ADDENDUM
NO. 2

July 23, 2020

Additions & Renovations to Lawrence North High School
7802 Hague Road
Indianapolis, IN 46256

ADDENDUM NO. 2
JULY 23, 2020

F. **Drawing Number EL1E1**

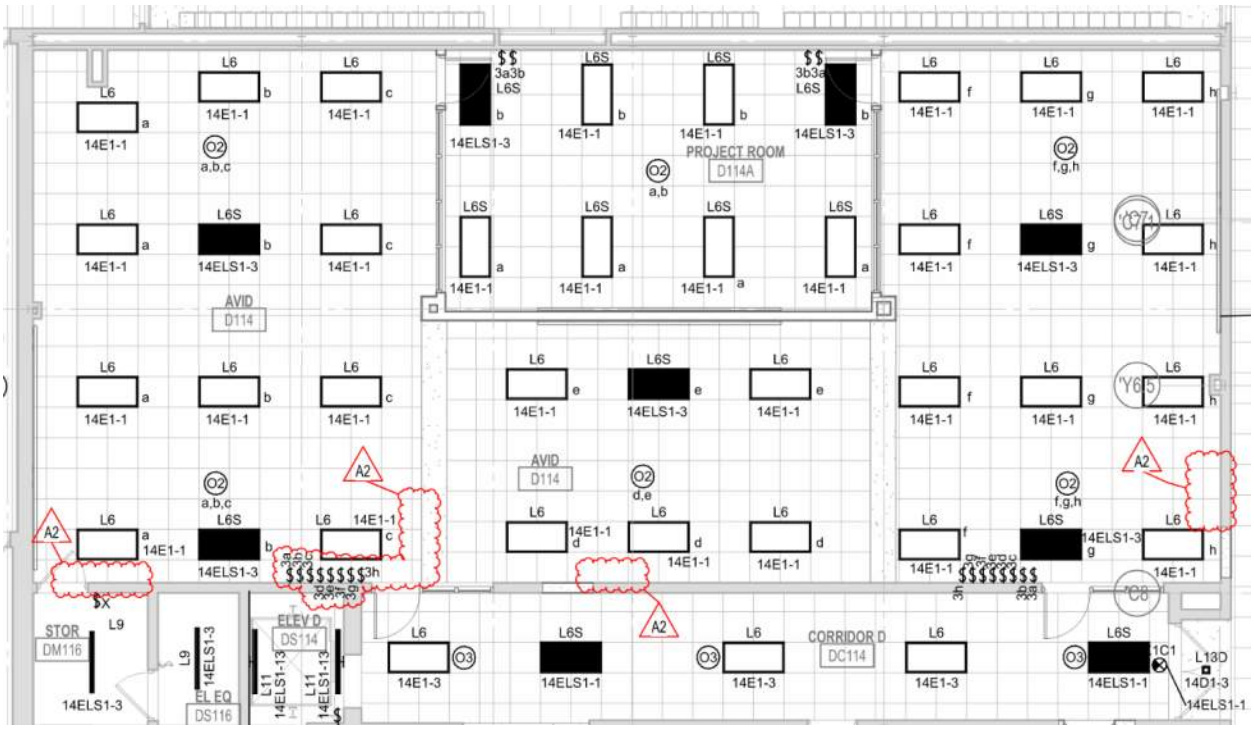
1. MODIFY Plan 1A/EL1E1 First Floor Lighting Plan Unit E as shown below:

G. **Drawing Number EL1E2**

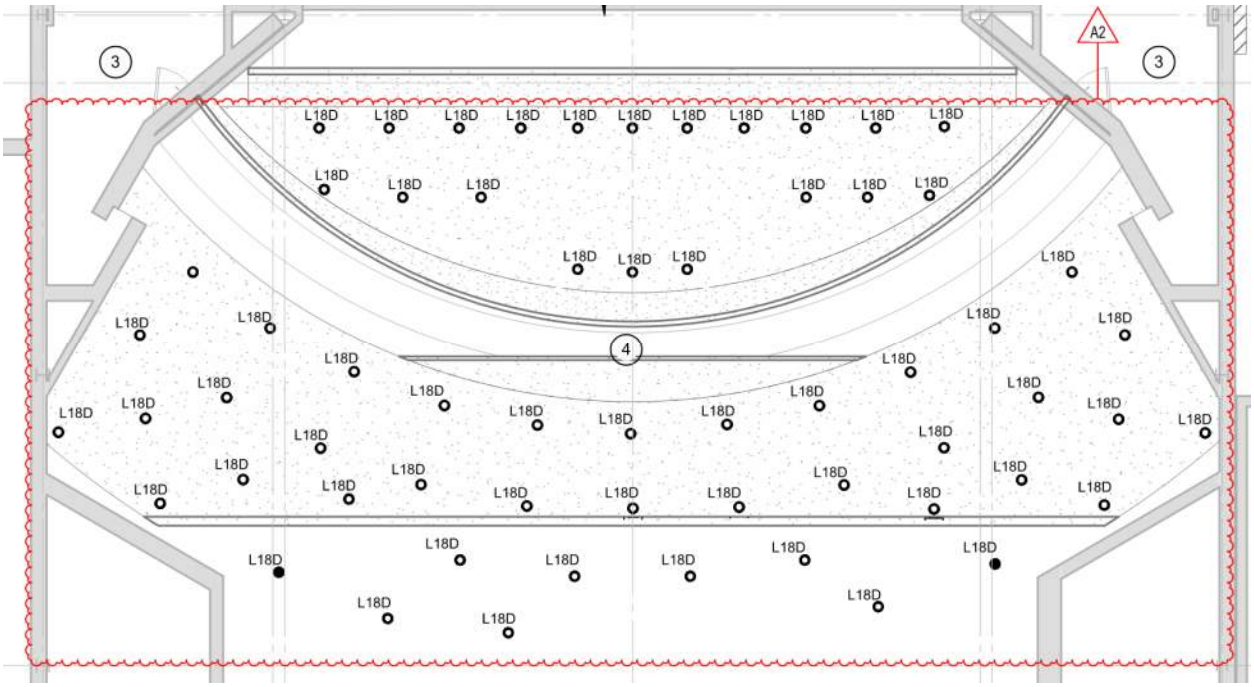
1. MODIFY Plan 2A/EL1E2 as shown below:

H. **Drawing Number EL1F1**

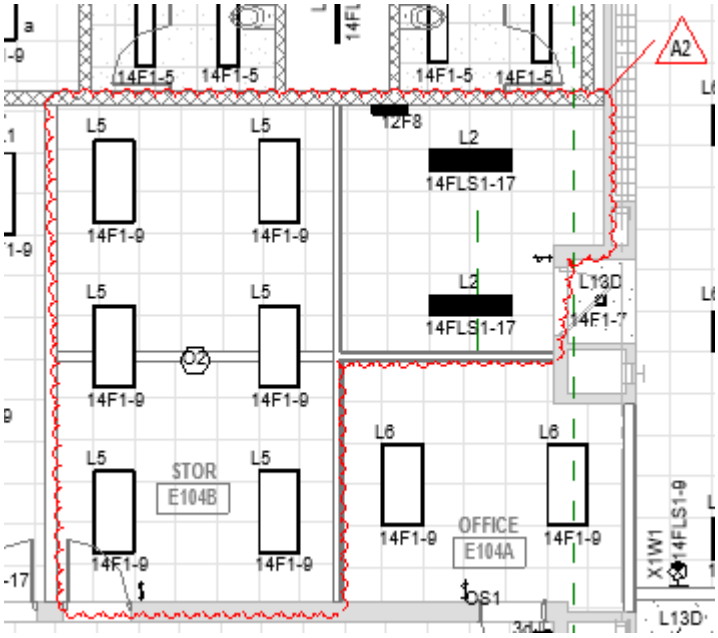
2. At E110B:

a. Change (4) light fixture type L9 to (4) light fixture type L5.

b. Change wall mounted occ sensor switch to single pole low voltage switch.

c. Add ceiling mounted occupancy sensor "OS1" in center tile of ceiling grid.

d. MODIFY Plan 2A/EL1F1 as shown below:

I. **Drawing Number EL1G1**

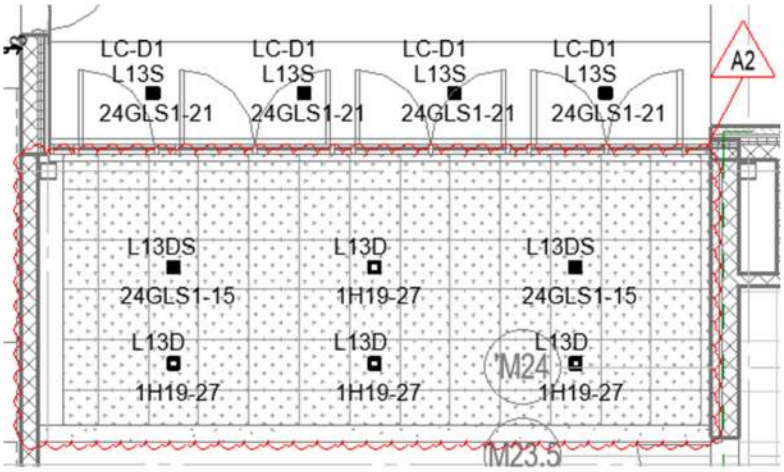
1. At Fieldhouse, on east wall, at south entry, change exterior light fixture to type L43.

2. At Fieldhouse, on east wall, at north overhead door, add (1) exterior light fixture type L45. Connect to circuit 24GLS1-21 and control from LC-D1.

3. At Fieldhouse, on north wall, at entries, change (4) exterior light fixtures to type L45.

4. MODIFY Plan 1A/EL1G1 as shown below:

M. **Drawing Number EP1F1.**

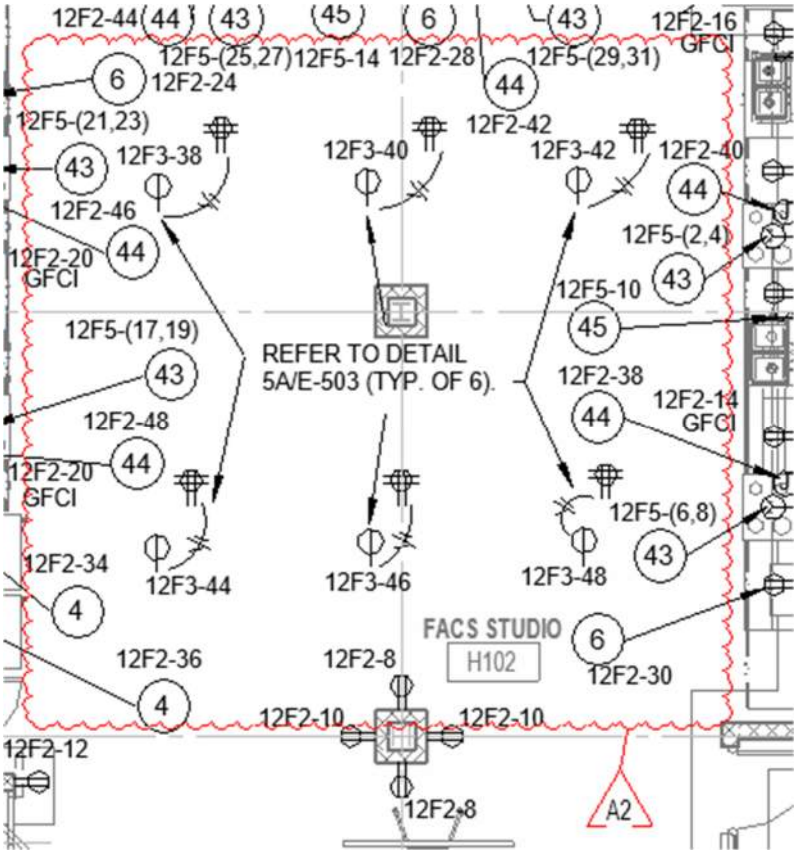
1. In H102, add (6) ceiling receptacles and associated quad drops as shown below. Circuit receptacles as shown below. Provide 20A circuit breakers.

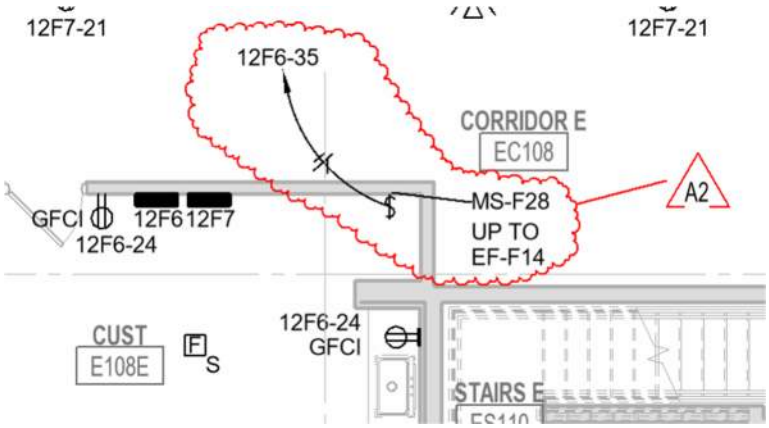
11. Add MS-F28 as shown below. Connect to circuit indicated. Provide 20A breaker.

N. **Drawing Number EP1K1.**

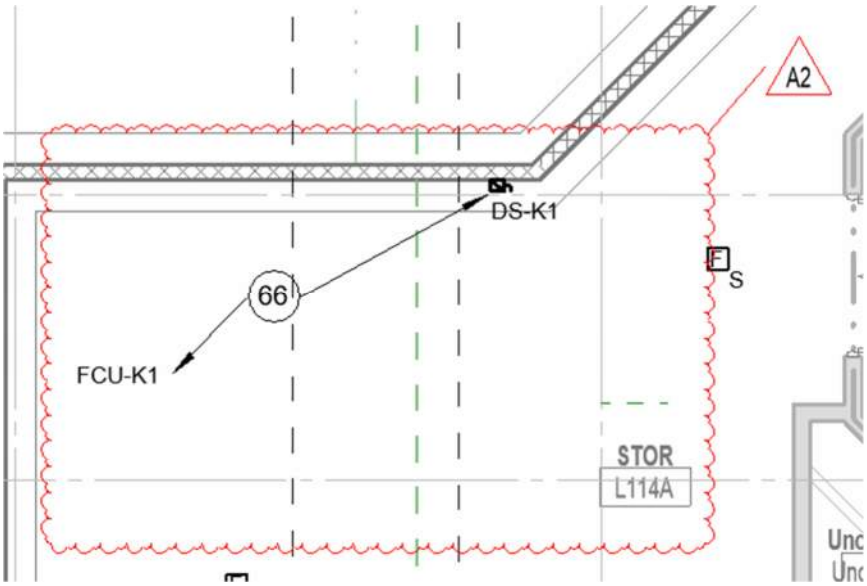
1. In L114A, add 208V, 30A, single phase, fused disconnect (fused at 25A) switch DS-K1 to serve FCU-K1 as shown below:

6D BM312A ELEC/BM314 IDF - ENLARGED POWER PLAN
1/4" = 1'-0"

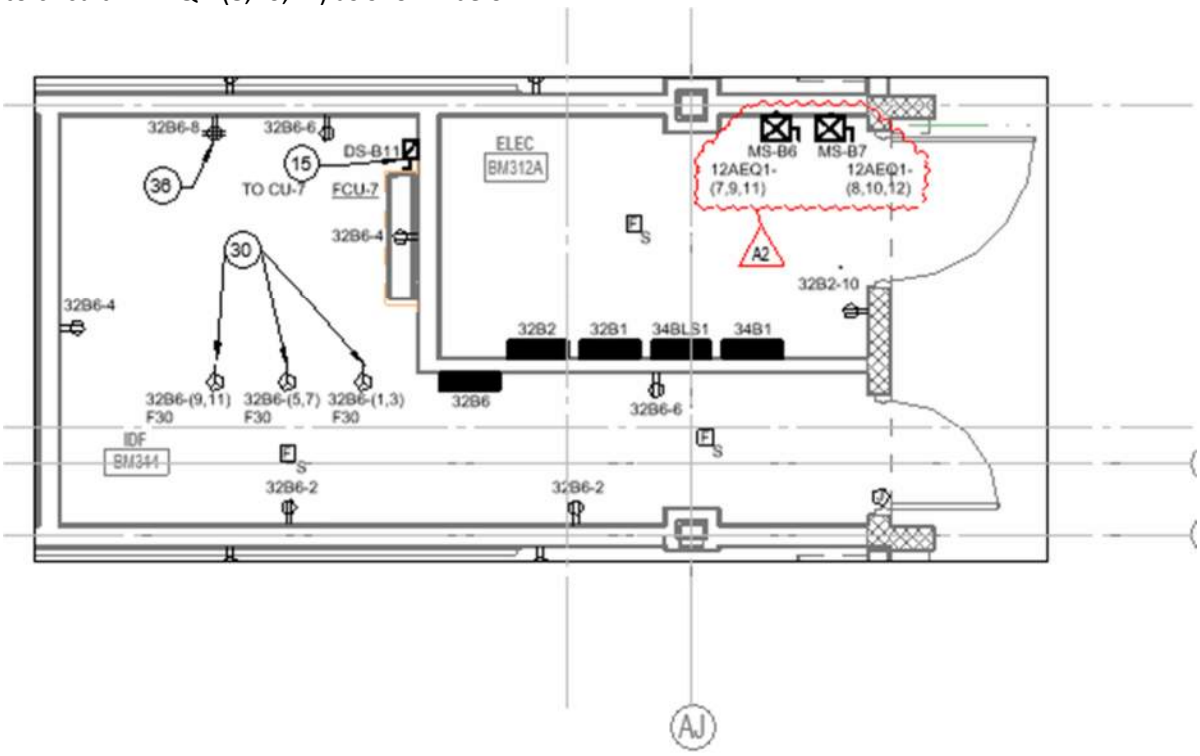
1. In Plan 6D, BM312A, ELEC, connect MS-B6 to circuit 12AEQ1-(7,9,11) and connect MS-B7 to circuit 12AEQ1-(8,10,12) as shown below:

S. **Drawing Number ER102.**

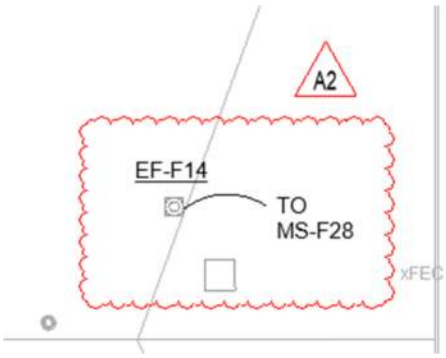
10. Connect EF-14 to MS-F28 as shown below:

U. **Drawing Number E-401.**

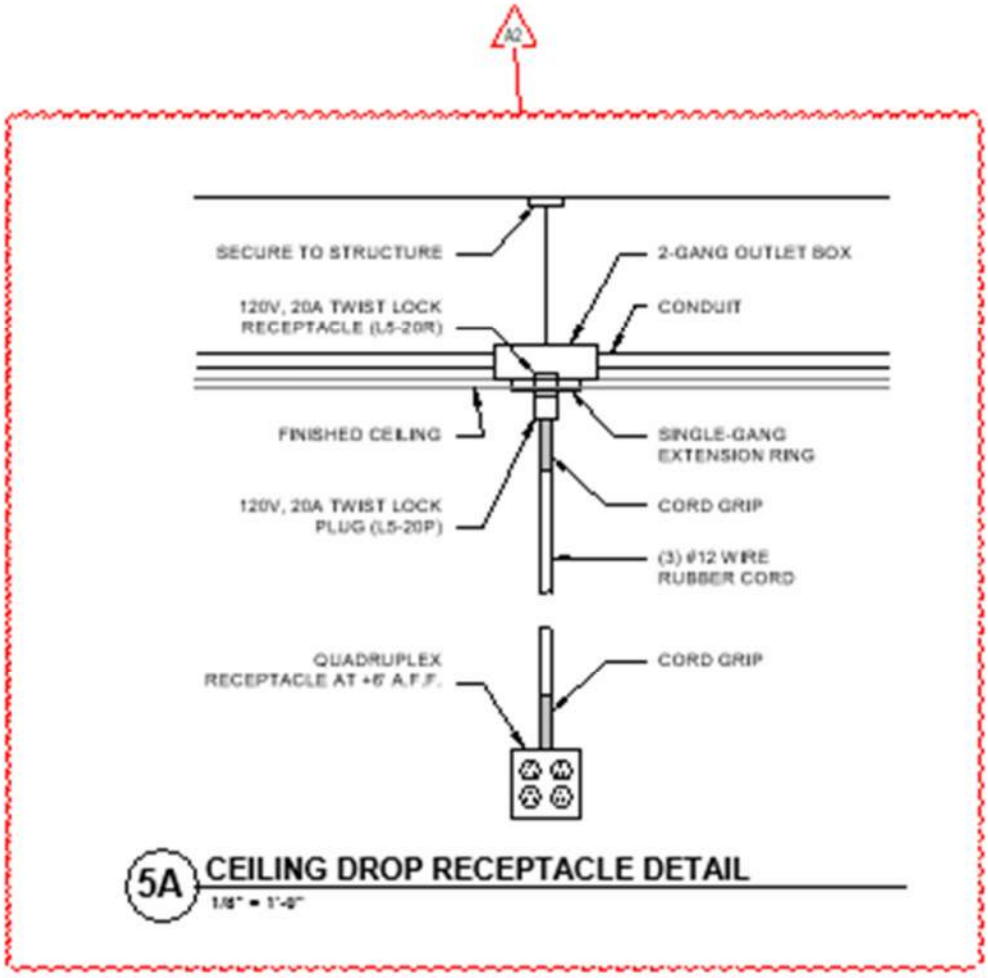
2. Add detail "5A / CEILING DROP RECEPTACLE DETAIL" as shown below:
